**BULLETIN**

SUBJECT: REWORKING OF BOTTOM COWL FOR REPLACING AIR SCOOP  
EQ5259 WITH EQ5370 (CONTINENTAL PART NUMBERS)

MODELS AFFECTED: J3C AIRPLANES

ENGINE BOTTOM COWL FRONT

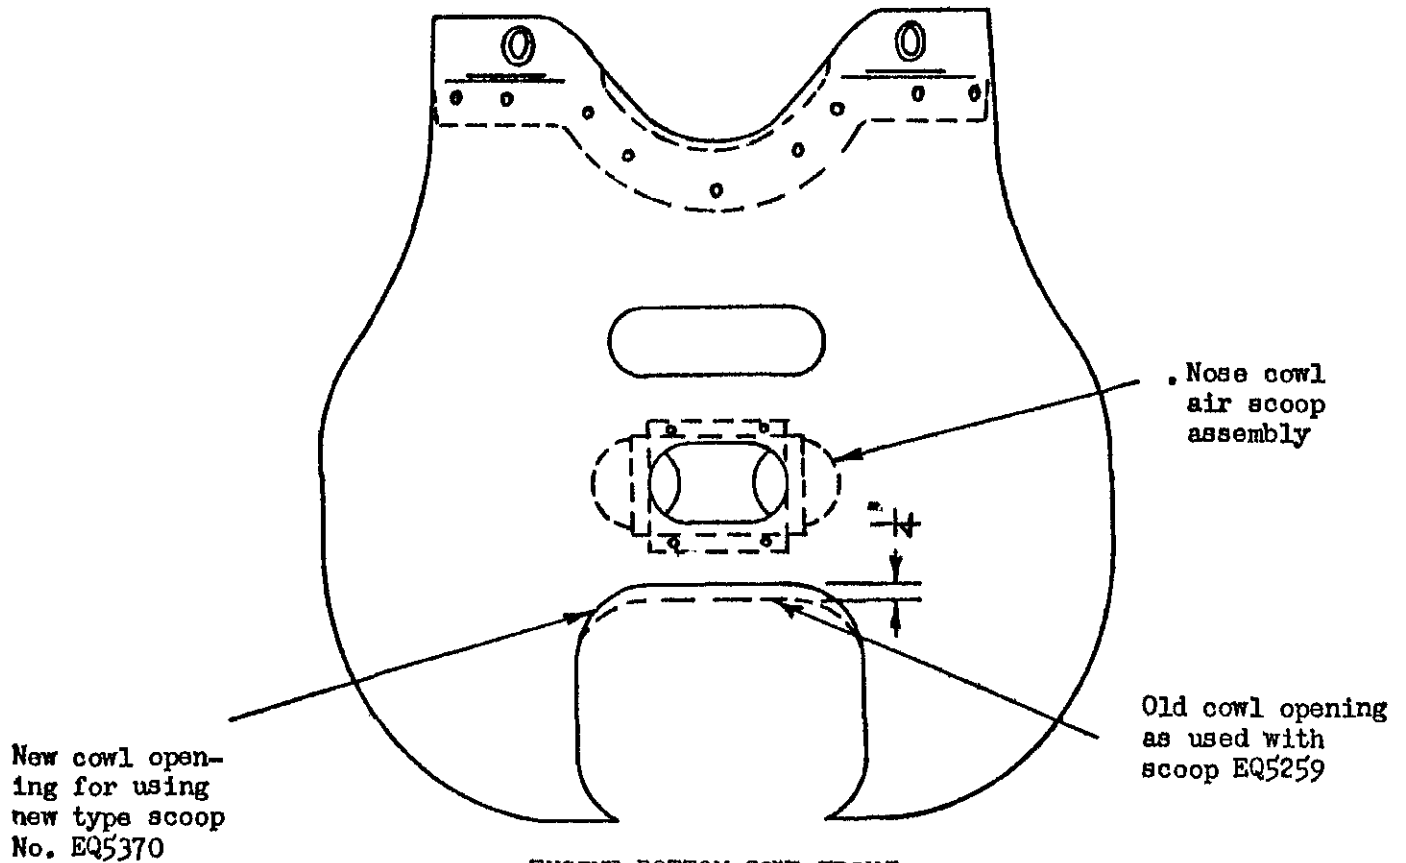
When replacing the vertical faced filter air scoop (Part No. EQ5259) with the new slant faced filter air scoop (Part No. EQ5370), the bottom cowl assembly will have to be reworked as per sketch below.
